ONSITE SEWAGE DISPOSAL SYSTEM

MEMORANDUM

RE: Chapel Meadows Lot 3 BAT Plan

BAT SITE PLAN
CHAPEL MEADOWS
LOT 3

PERFORMANCE RATINGS

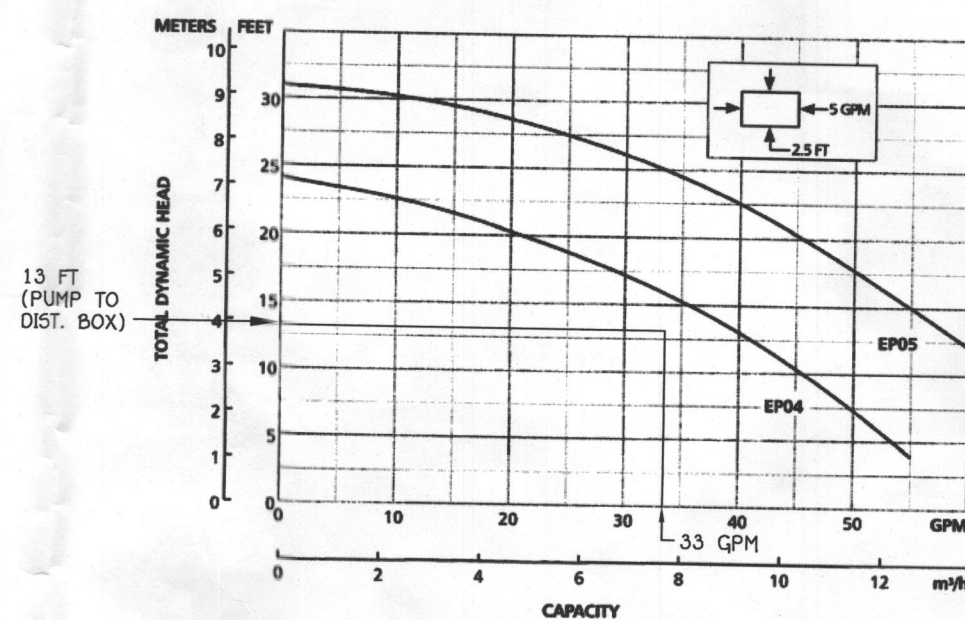
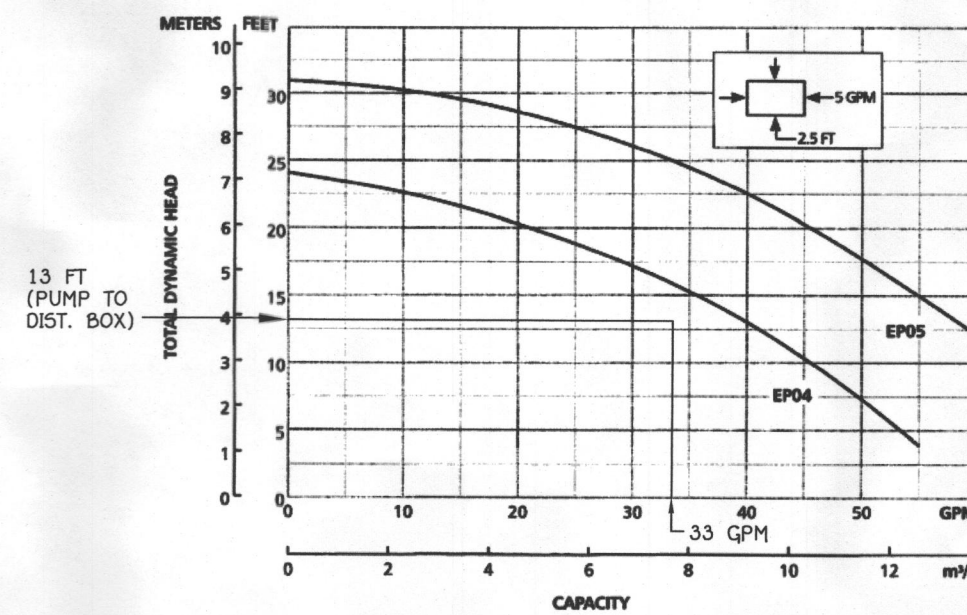
- Both effluent pump charts are illegible. Show legible charts and clearly indicate which pump is being chosen for the system.
- There is space on page two of the plan to fit the head calculations submitted as a supplemental sheet. Please add them to the main plan page two.

- Plot the point on the pump curve according to the appropriate head.
- Revise the dose for the system to be closer to around 40-50 gallons entering the d-box (factor in volume in force main)

1. Spacing has been revised as requested.
2. Trench locations have been revised as requested.
3. Invert elevations of trenches have been revised as requested.
4. Pump charts have been made more legible as requested.
5. Head calculations have been added to sheet 2 as requested.
6. Pump tank detail has been revised as necessary based on changes.

1000 GALLON
RECTANGULAR PUMP TANK

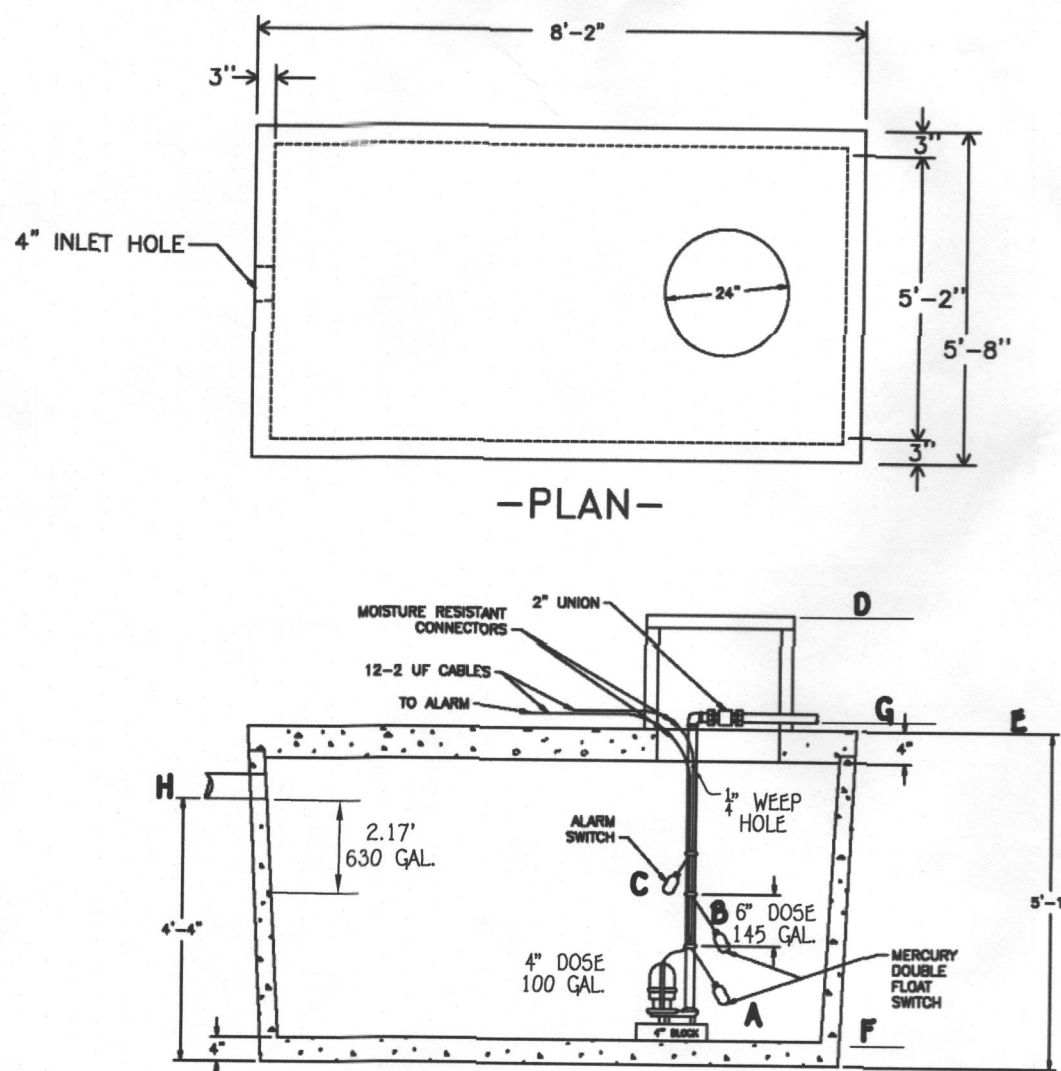
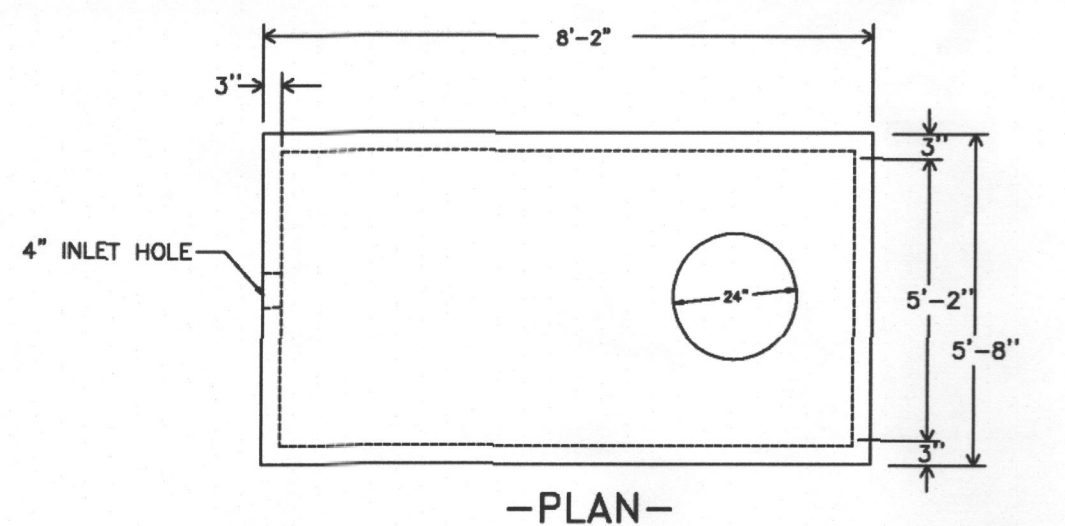
- The pump tank cross section indicates a 3" vertical separation between on and off floats as well as a 2.5' separation between alarm float and inlet invert while the pump details below show float elevations 6" apart for on and off floats and a 3' elevation difference between alarm float and inlet invert. Revise so they agree while still providing for the dose chosen and the appropriate emergency storage.

- On the pump tank cross section, show a weep hole in the discharge line inside the tank for backflow discharge.
- Show the calculations for dynamic head: static head and friction head details.

- The pump tank cross section indicates 3" thick walls. Either show a 4" thick wall or add a note stating that the tank must be watertight tested in the field due to 3" thick walls.

PER HEALTH DEPARTMENT REQUIREMENTS,
THIS PUMP TANK MUST BE WATER-TIGHT
TESTED IN THE FIELD DUE TO 3" THICK
WALLS.

BAT SITE PLAN
CHAPEL MEADOWS
LOT 3

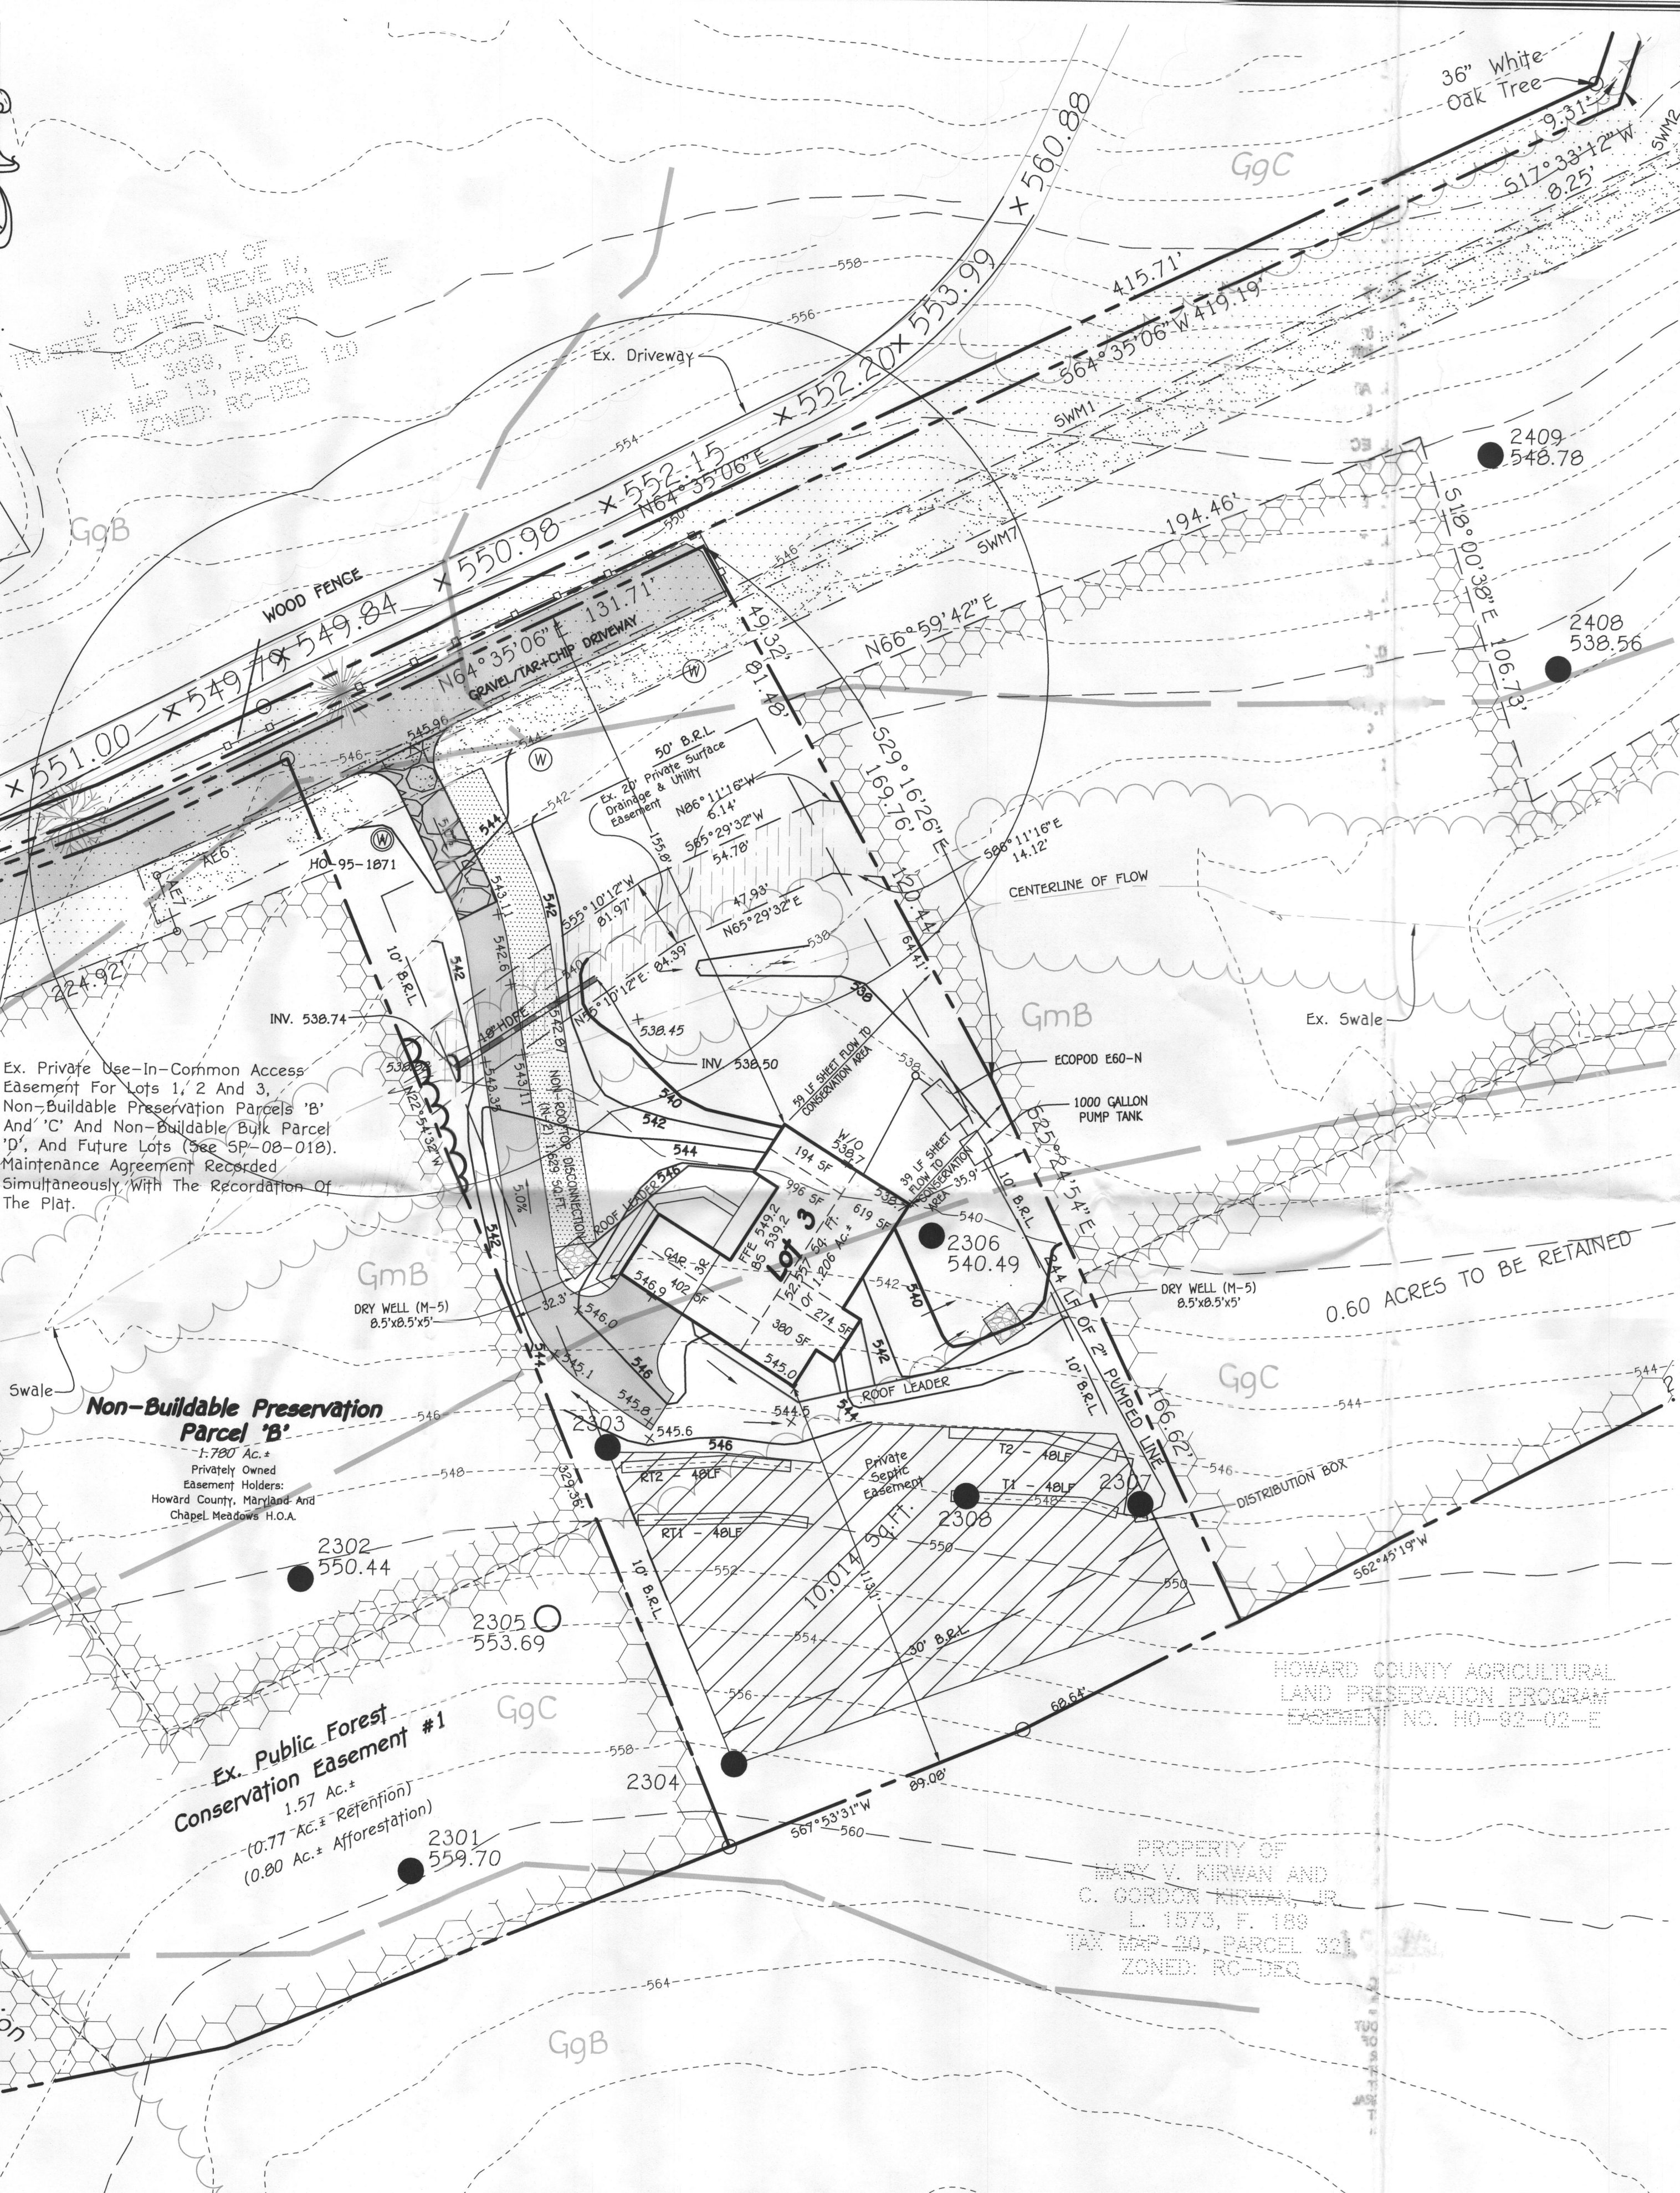
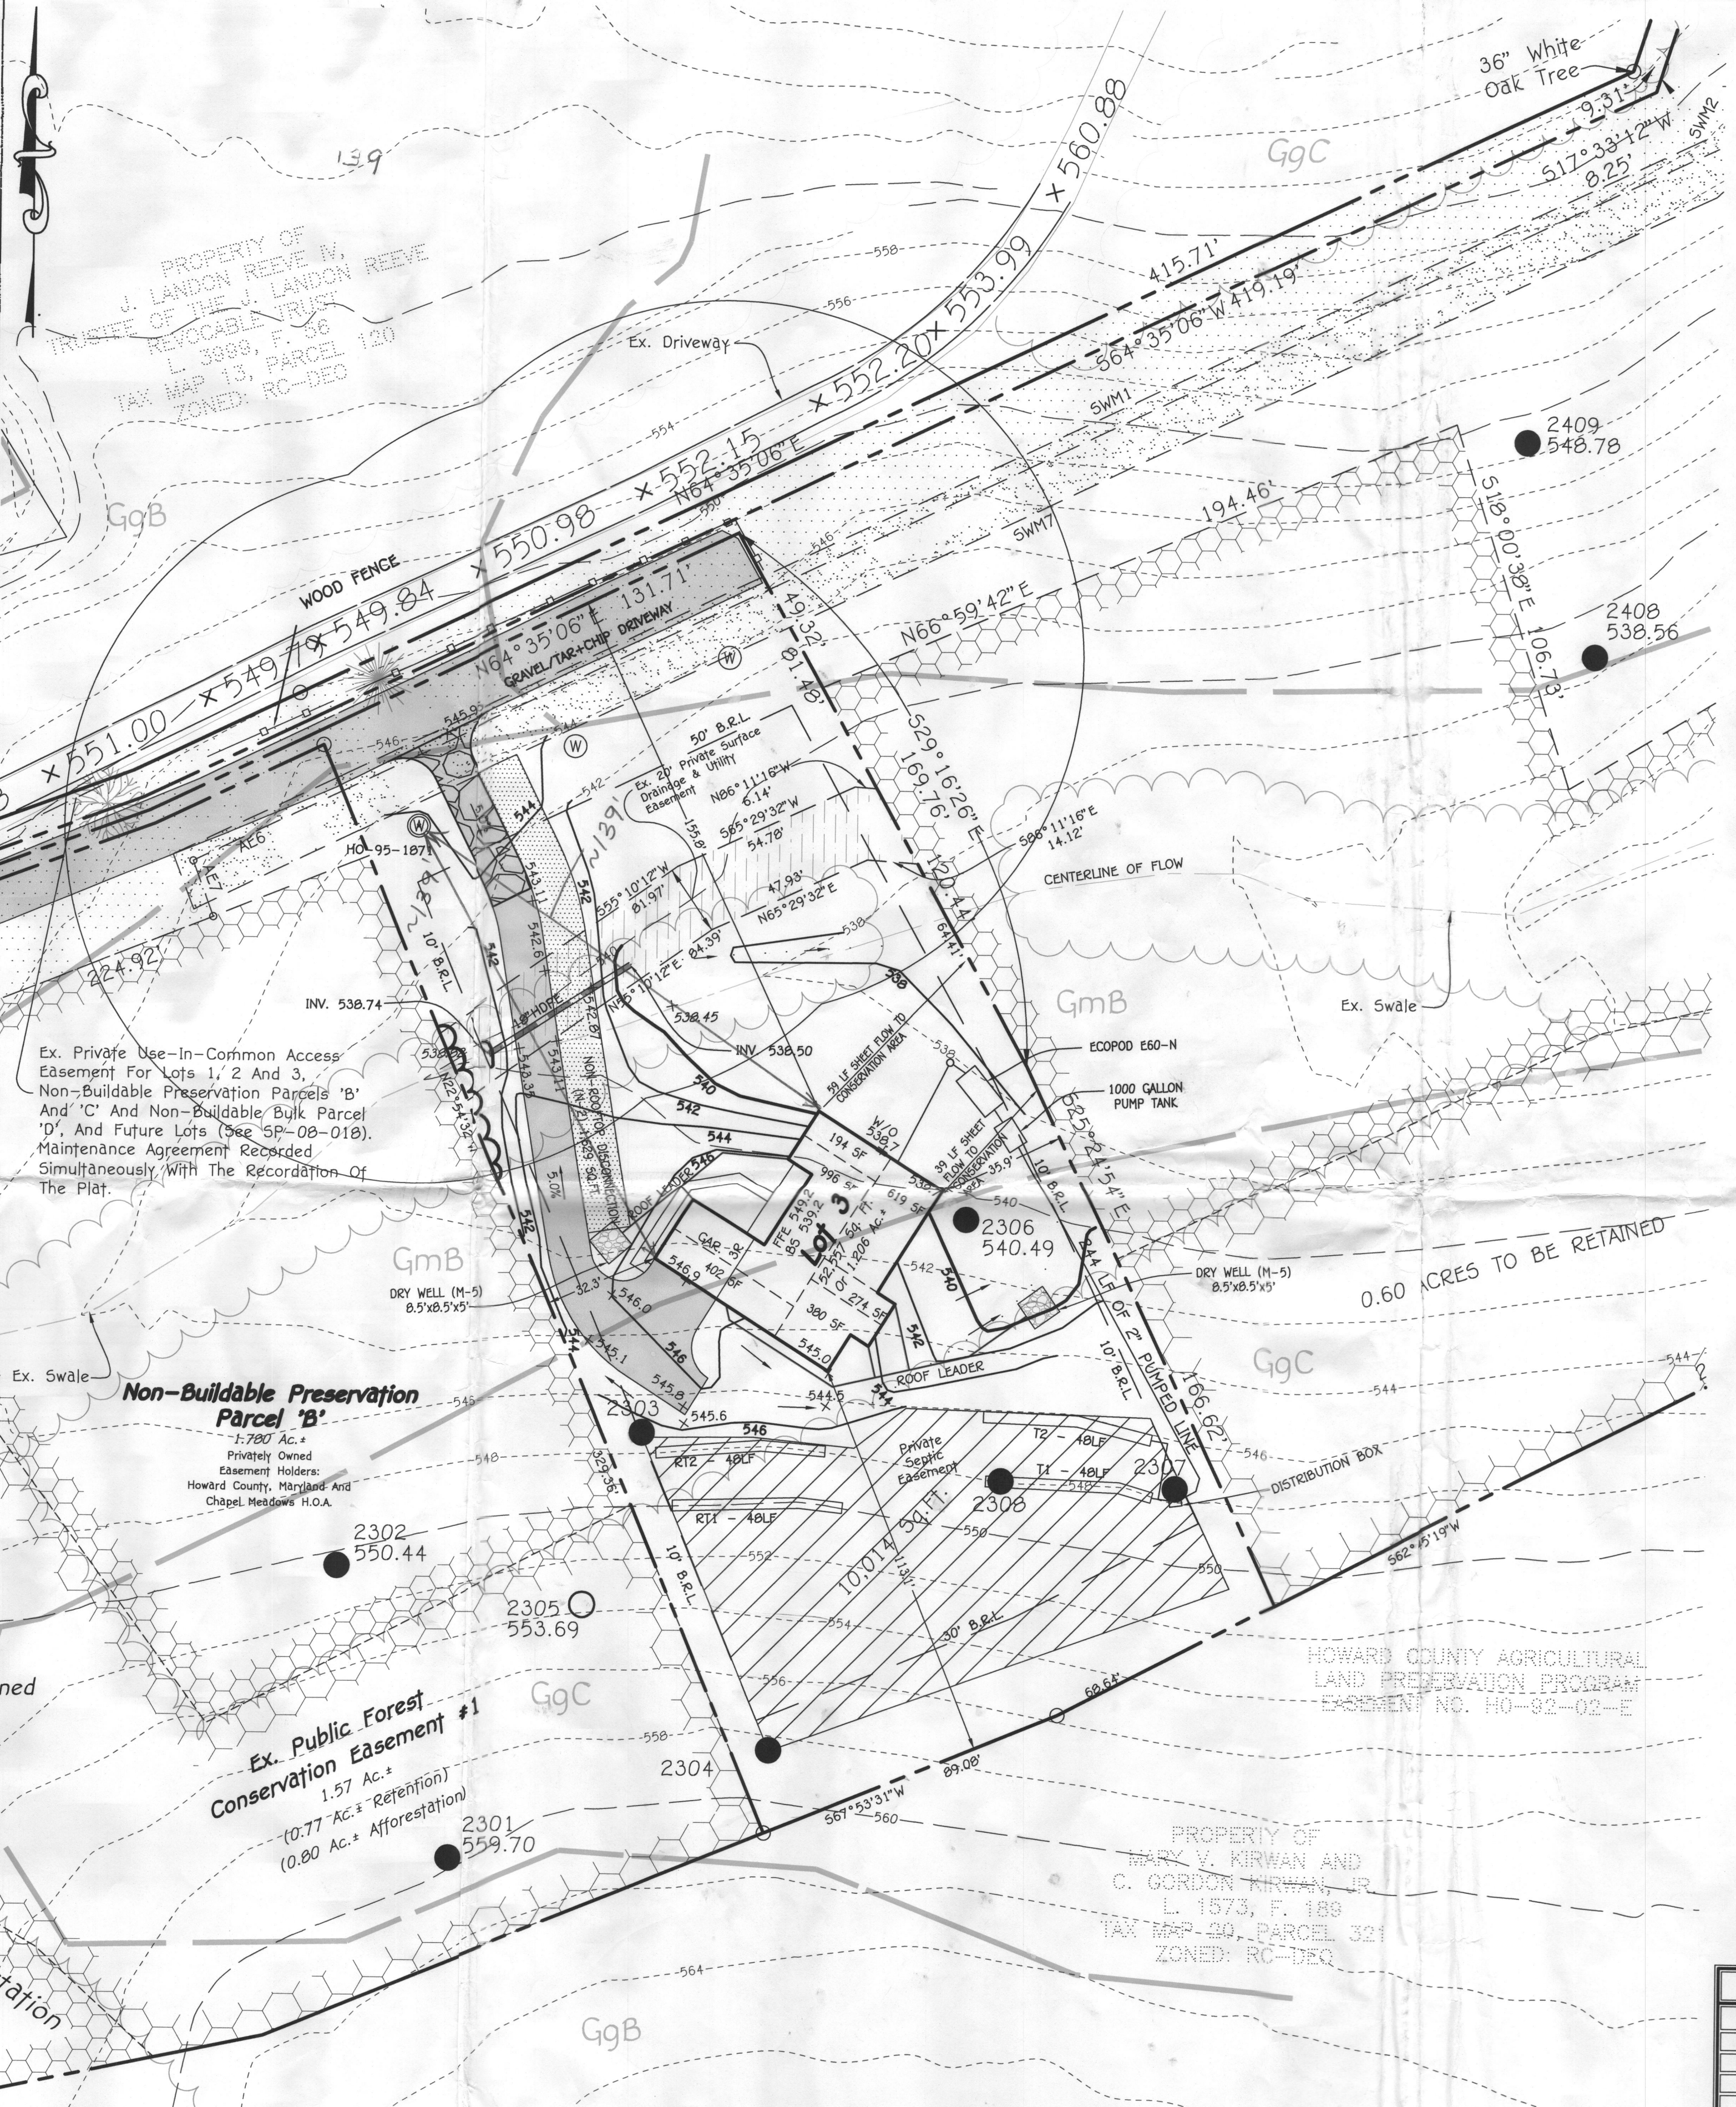
- On the septic system design details and on the trench layout in the site plan, the trench spacing must be 12 feet edge to edge.
- Revise the trench locations on the site plan to show the lower trenches (currently labeled as the replacement trenches) as the initial system and move the replacement system over to be located near test hole 2303. Revise all piping and head calculations accordingly.

- The invert elevations for all trenches are listed at 4' depth while the effective area begins at 3.5' depth. Raise the invert elevations for all trenches to 3.5' depth in order to take full sidewall credit.

- The BAT plan shows well locations and a Sewage Disposal Area that differ from the signed perc certification plan for the lot. A revised perc cert must be submitted and signed by the Health Officer in order to revise those locations. Please note that one well location will not be approvable based on proximity to the stormwater culvert. It must be moved so that it is at least 50' from the culvert inlet and discharge point.

- Indicate the ground, invert, and bottom elevations for each trench in the initial and reserve systems.
- The trench spacing for trenches using sidewall credit is 10' according to newly revised COMAR guidelines.

- Revise the trench locations so that both the initial and 1st replacement systems are along the bottom portion of the reserve away from hole 2304. The specs for that area are application rate of 0.8, effective area beginning at 3.5' and trench bottom at 8'.
